CITY OF SAVANNAH

REQUEST FOR CERTIFICATE OF APPROPRIATENESS

MPC File No.: 26-002721-COA

Address: 220 West Duffy Street

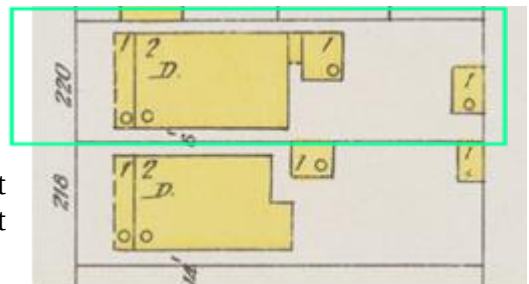
220 West Duffy Street was built in 1885 and is a contributing resource within the National Register Victorian Historic District and the local Victorian Historic District. There are several similar contributing resources along the block. From the Sanborn Maps (1898 shown at right), it appears that there had been a small one-story accessory structure at the rear of the property, which is no longer extant.
